Re: **Gude Landfill – Nature and Extent Study – Amendment No. 1**

Gude Landfill – Nature and Extent Study MDE Comments / County Responses

Documentation to Prepare Amendment No. 1

FIGURE-A
NATURE AND EXTENT STUDY AMENDMENT NO. 1
PROPOSED ADDITIONAL GROUNDWATER MONITORING LOCATIONS

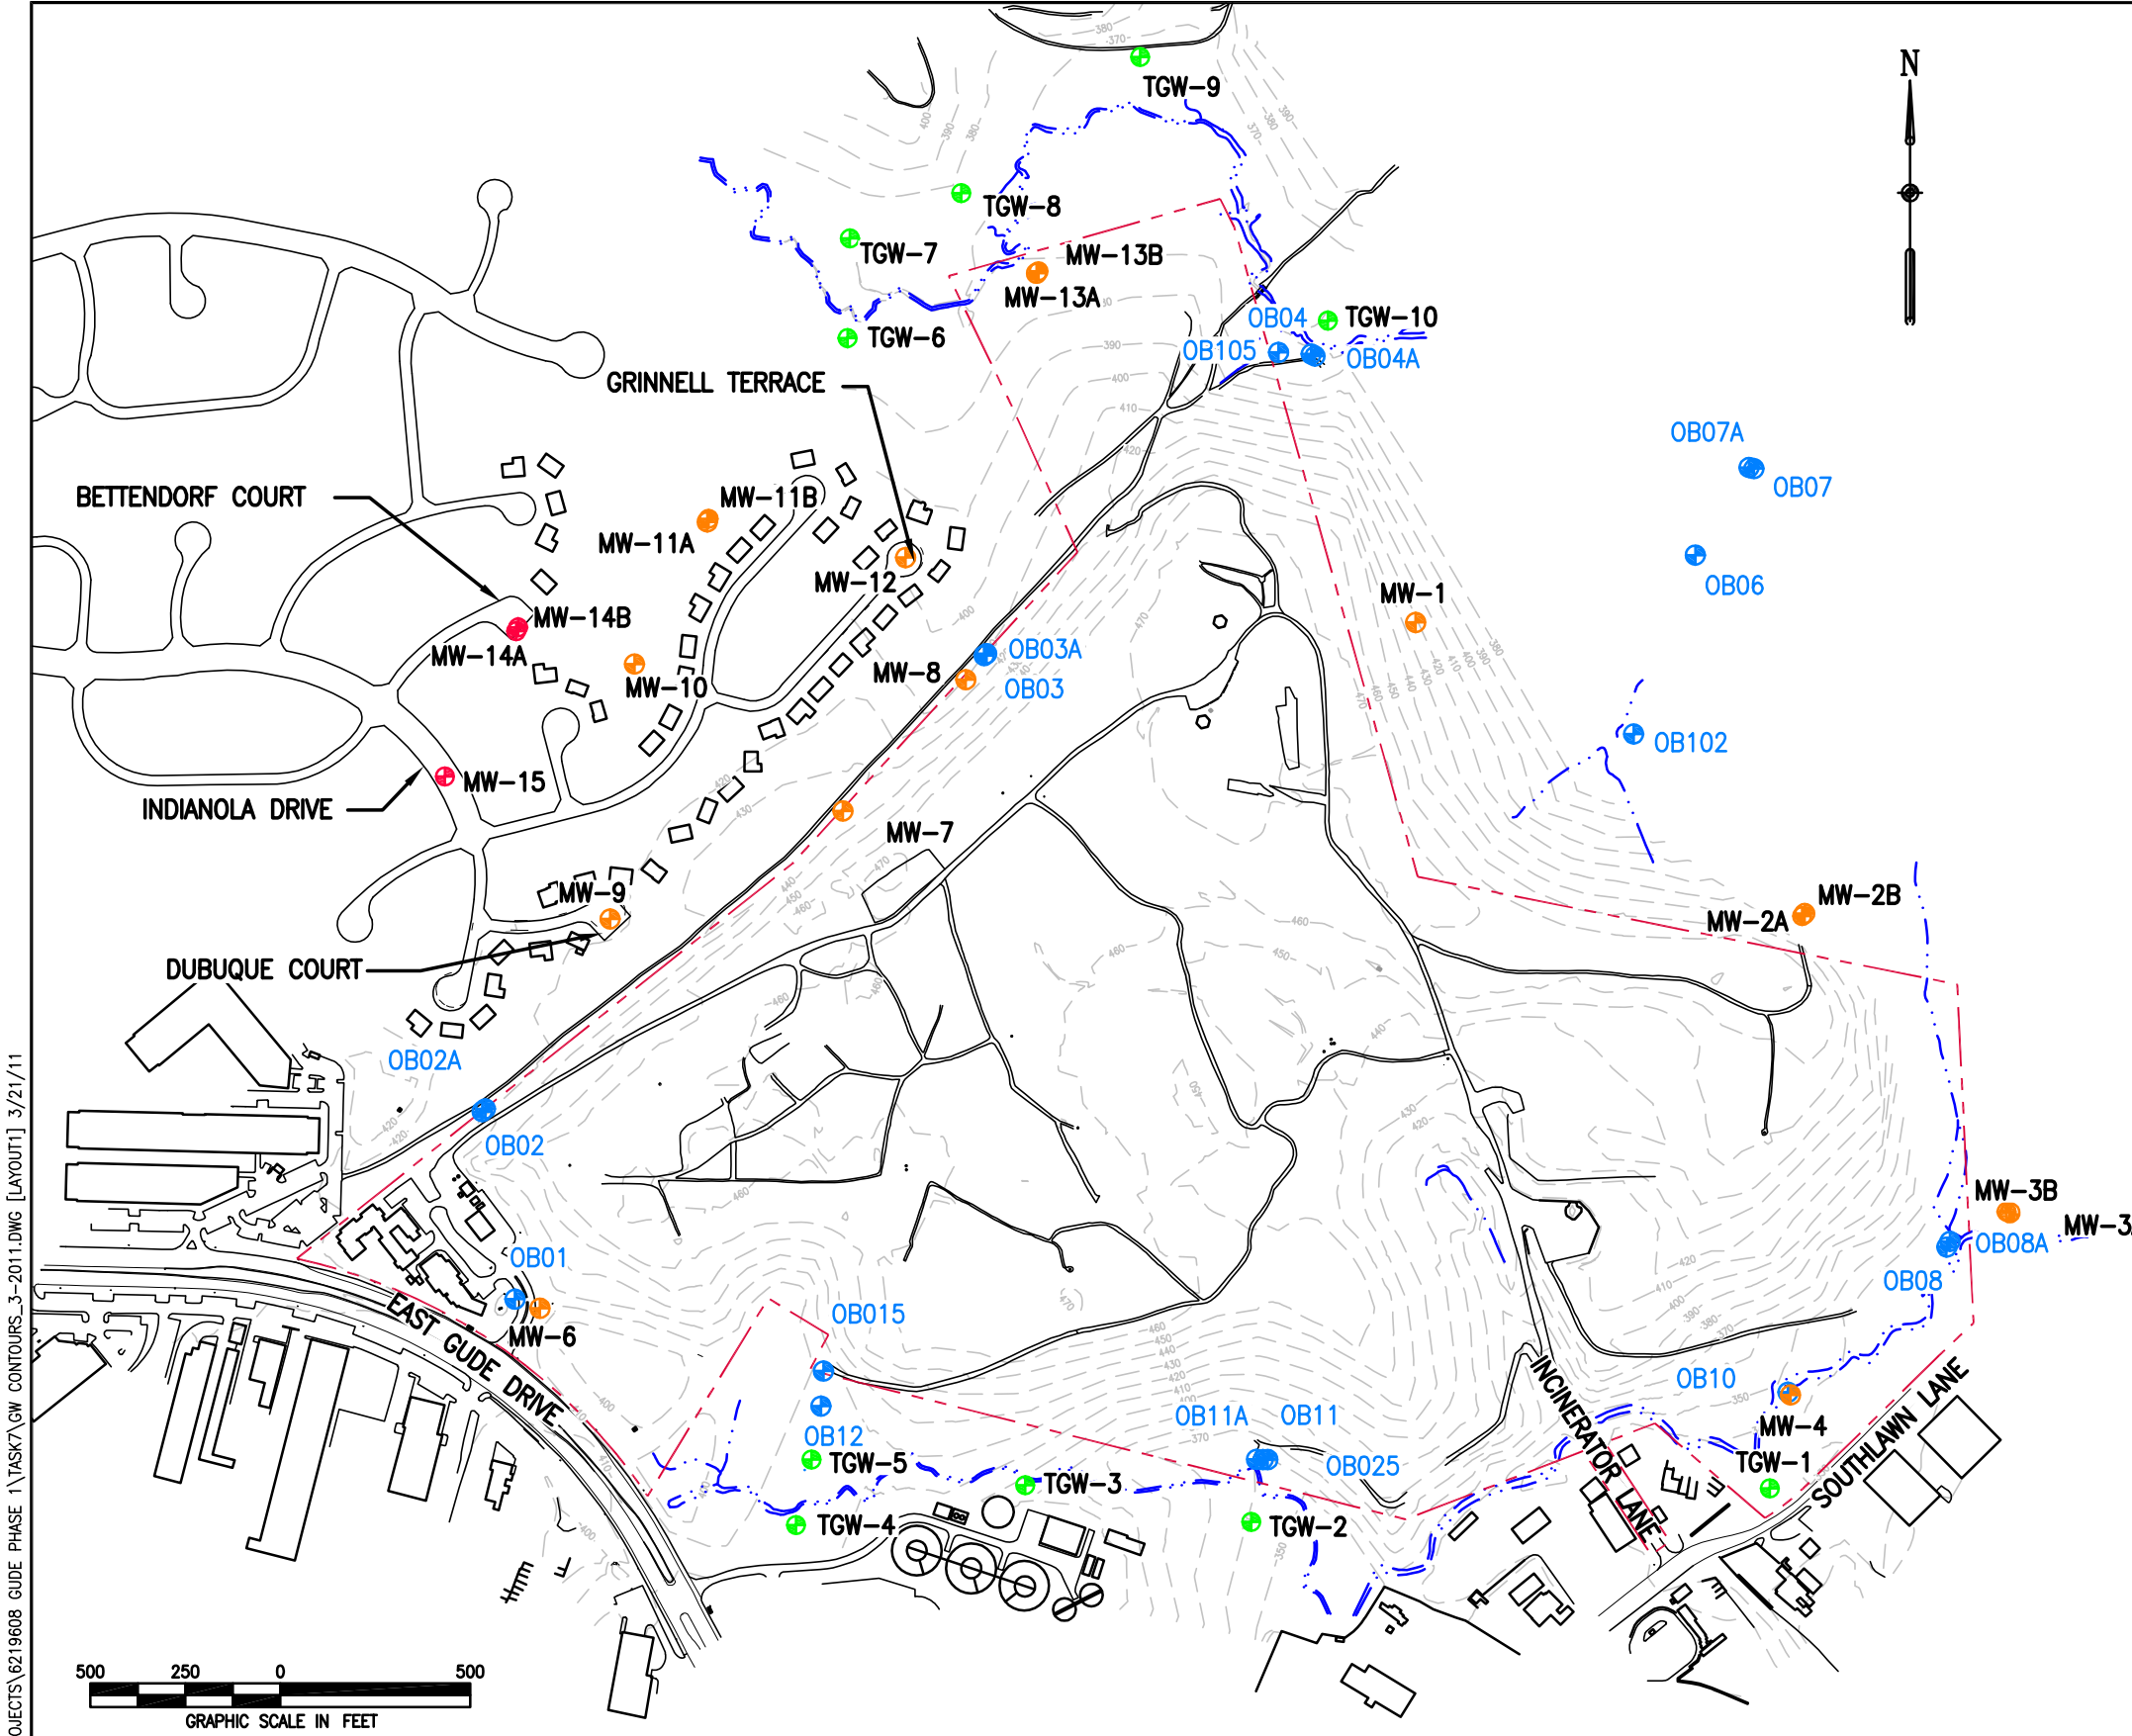
3) ***MDE – Maximum contaminant level (MCL) exceedances were noted at the Landfill property boundary, beyond the waste footprint and in the Derwood Station Community. The extent of MCL exceedances need to be further evaluated and characterized through additional groundwater sampling and analyses in the following areas of the Landfill site: northwest, northeast, south-central and southeast. Seasonal variation trends in the groundwater sampling data (e.g. fluctuations in constituent concentrations) should also be considered and evaluated.***

- County – Will further assess and bound the extent of potential impacts to groundwater through additional sampling and analyses in the following areas of and in vicinity of the Landfill site: northwest, northeast, south-central and southeast.
- County – Will acquire the necessary permits and land approvals to install and monitor three (3) proposed additional groundwater monitoring wells in the Derwood Station Community, which are to be located northwest of the Landfill property. MW-14A/14B

are proposed to be installed in Bettendorf Court (shallow/deep well pair down gradient of MW-9). MW-15 (shallow well cross-gradient of MW-9) is proposed to be installed near the intersection of Indianola Drive and Grinnell Drive. The groundwater monitoring wells will be installed using hollow stem auger and/or air rotary drilling techniques: Refer to Figure A – Proposed Additional Groundwater Monitoring Locations.

- County – Will acquire the necessary permits and land approvals to install and monitor ten (10) proposed temporary groundwater monitoring locations, which are to be located northwest (MW-13A/13B), northeast (OB105, OB04, OB04A), south-central (OB15, OB12, OB11, OB11A, and OB025) and southeast (OB10 and MW-4) of the Landfill property adjacent to and on opposing sides of the neighboring surface water bodies (Crabbs Branch Stream and Southlawn Branch Stream) in areas that may not be accessible by traditional drilling equipment. The proposed temporary groundwater monitoring locations will be installed by either direct push (geo-probe) equipment or through hand augering and will be installed to depth that penetrates the groundwater surface. Refer to Figure A – Proposed Additional Groundwater Monitoring Locations.

FIGURE-B
NATURE AND EXTENT STUDY AMENDMENT NO. 1
PROPOSED STREAM GAUGE LOCATIONS

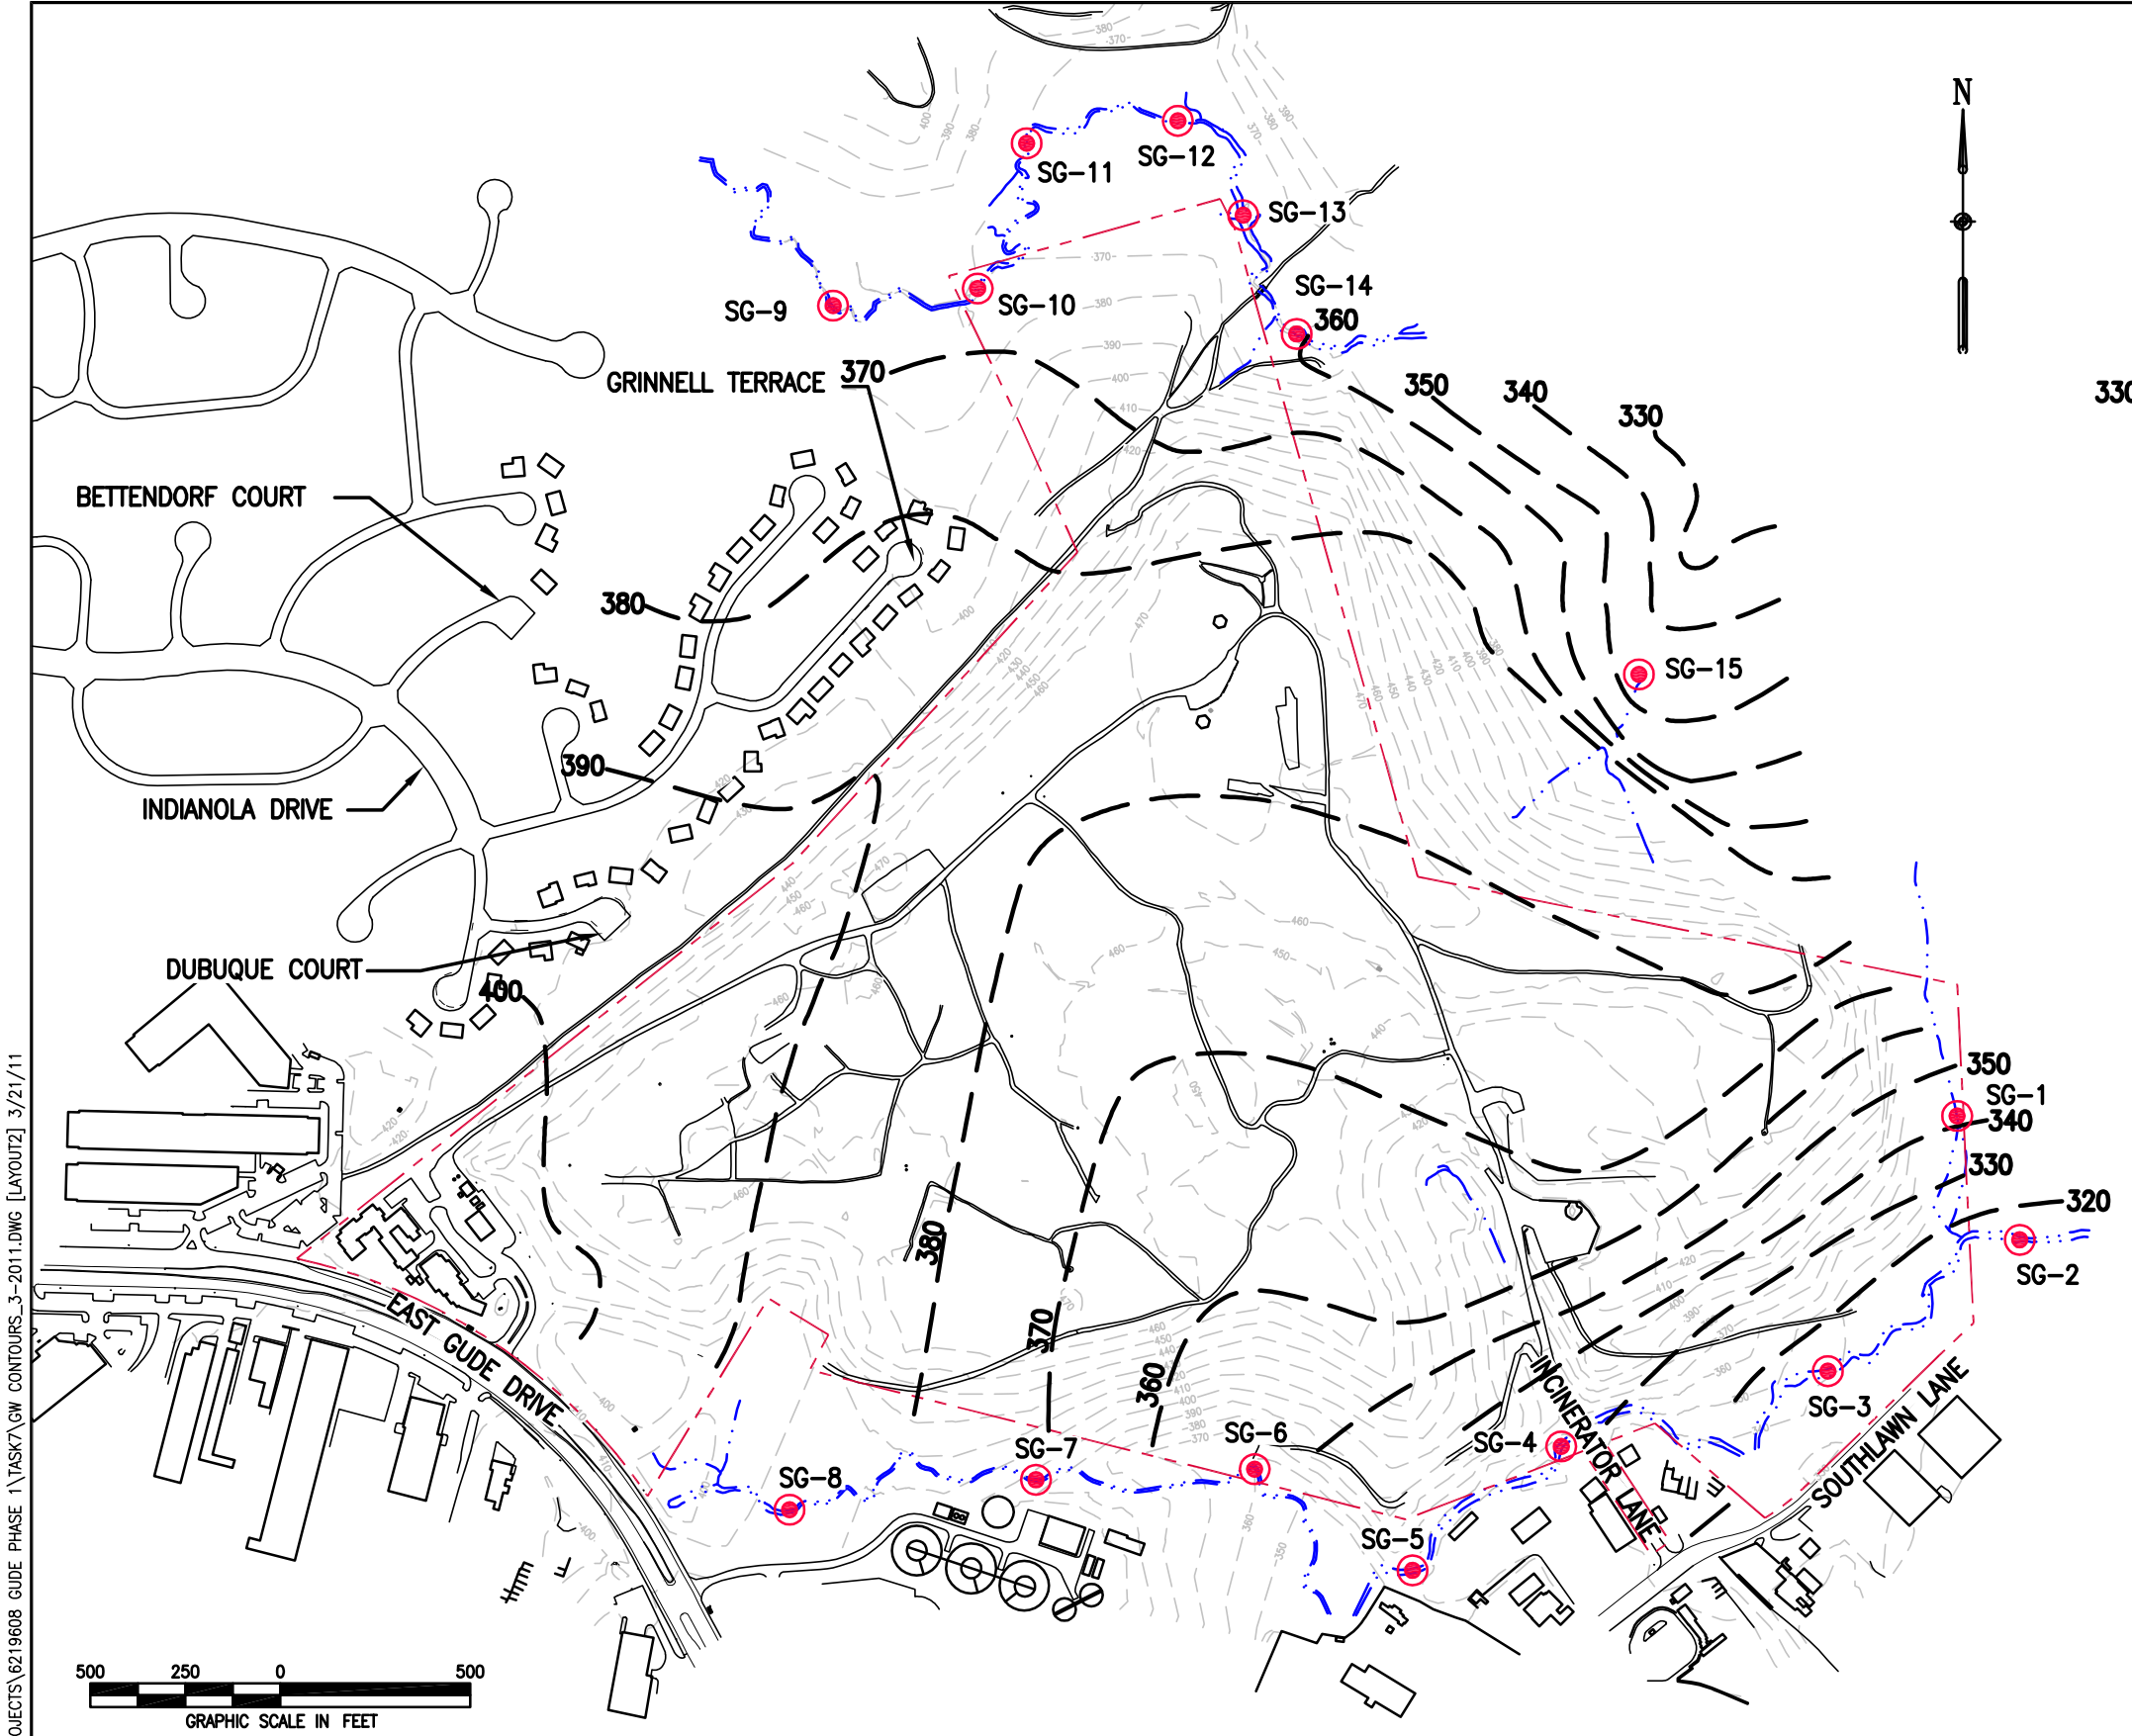
9) MDE – *The NES Report groundwater contour map and related text should more closely reflect aspects of the Landfill's topography and the apparent flow direction of surface water bodies along the perimeter Landfill property boundary. More localized (e.g. radial) groundwater flow components in these areas of the Landfill site should be provided in an attempt to close the groundwater contours. Surface water elevations from bordering streams should be measured and included in the groundwater contour details.*

- County – Will install approximately fifteen (15) temporary stream gauges in the surface water bodies along the perimeter Landfill property boundary to obtain stream elevation data for incorporation into the groundwater contour map. The stream gauges will be tied into the Landfill site topography through field survey from the existing groundwater monitoring wells along the northwest/northeast, and south central/southeast Landfill property boundary. Refer to Figure B – Proposed Stream Gauge Locations.

- The groundwater contour map will incorporate the relationship of site topography and the apparent flow direction of surface water bodies along the perimeter property boundary of the Landfill. Where possible, more localized (e.g., radial) groundwater flow components will be addressed in these areas of the Landfill site in an attempt to “close” the groundwater contours.
